Access Compliance Report

Public Rights-of-Way

(Curb Ramps)

Intersection ID: 10038458	Main Street: SOUTHERN_PINE_BV	Cross Street: N/A	Location: NE
ADA ID: E56DFB05D666	Ramp Type: PerpDiag	Initial Pass/Fail: Fail	Overall Compliance: No
Severity Score: 58.75			
Codes/Mitigation Info/Possible Solution		Field Measurements/Component Compliance

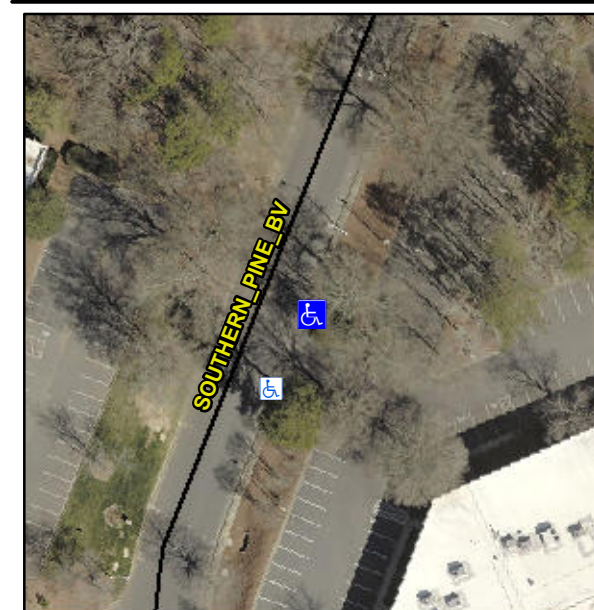
Not Found, R304.5.1, R304.2.2, R304.5.3

Compliance	Description	Data	Compliance	Description	Data
N/A	Ramp Length (in)	44.0	No	Ramp Slope (%)	14.5
No	Ramp Width (in)	42.0	No	Ramp XSlope (%)	11.6
N/A	Flare Type LT	N/A	N/A	Flare Type RT	N/A
N/A	Flare Slope LT (%)	N/A	N/A	Flare Slope RT (%)	N/A
N/A	Flare Traversable LT?	N/A	N/A	Flare Traversable RT?	N/A
N/A	Landing Length (in)	N/A	N/A	DWS Provided?	N/A
N/A	Landing Width (in)	N/A	N/A	DWS Contrast?	N/A
N/A	Landing Slope (%)	N/A	N/A	DWS Length (in)	N/A
N/A	Landing X Slope (%)	N/A	N/A	DWS Full Width?	N/A
N/A	Landing Curb? (Y/N)	N/A	N/A	DWS Offset (in)	N/A
N/A	Shared Landing?	N/A			
N/A	Gutter Ponding?	N/A	N/A	Gutter Slope (%)	N/A
N/A	Gutter Lip Ht (in)	N/A	N/A	Gutter X Slope (%)	N/A
N/A	Painted X Walk1?	No	N/A	Painted X Walk2?	No
	X Walk 1 Direction	To W		X Walk 2 Direction	To S
N/A	X Walk 1 Width (in)	N/A	N/A	X Walk 2 Width (in)	N/A
	X Walk 1 Slope (%)	4.0		X Walk 2 Slope (%)	2.1
	X Walk 1 X Slope (%)	0.1		X Walk 2 X Slope (%)	10.6

Remove & Replace Curb Ramp With Two New Directional Ramps or Equivalent.
